INSTITUTION OF GAS ENGINEERS AND MANAGERS

IGEM/UP AND IGE/UP SERIES OF STANDARDS

AMENDMENTS. OCTOBER (2) 2010 (31 sides)

TABLE 5 - MINIMUM SPACING OF HORIZONTAL ROOM SEALED APPLIANCE TERMINALS FROM FACING FLAT SURFACES, OPENINGS AND TERMINALS

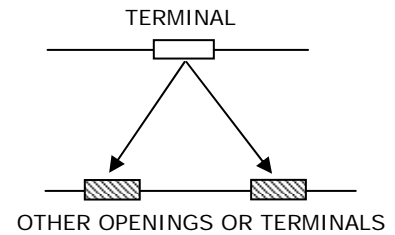
Table 5 Delete Table and title entirely. Substitute:

TERMINAL SITED FACING	NATURAL DRAUGHT	FORCED DRAUGHT
A flat surface	1.0 m	1.0 m
Another terminal	1.0 m	2.0 m
Another opening	2.0 m	3.0 m

FIGURE 38 – ASSESSMENT OF TERMINATION HEIGHT OF CHIMNEY – NATURAL GAS APPLIANCE

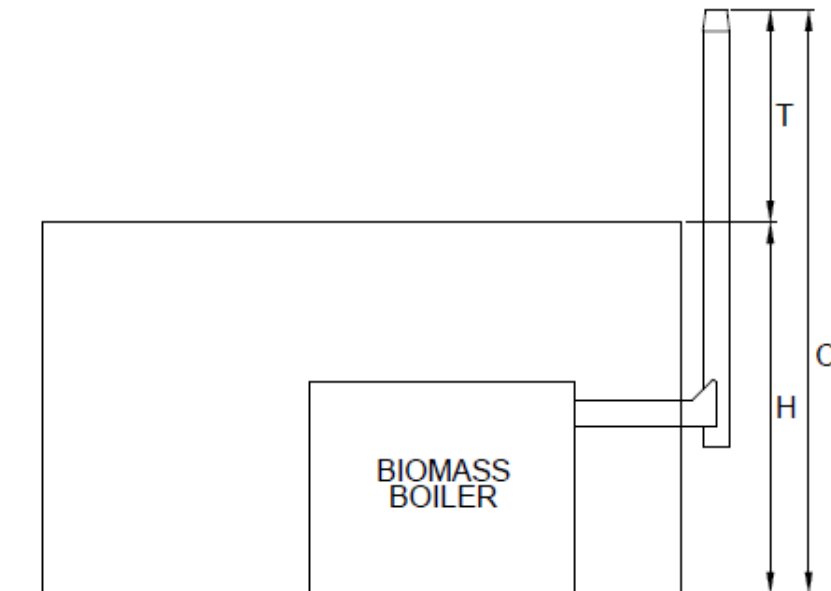
Assuming a single building within this radius of H= 4.0 m then the Corrected Chimney Height (C) = 4.0 + (0.6 x 0.9) = 4.54 m

This is less than the minimum 1.0 m required above the roof, therefore C is adjusted to 5.0 m
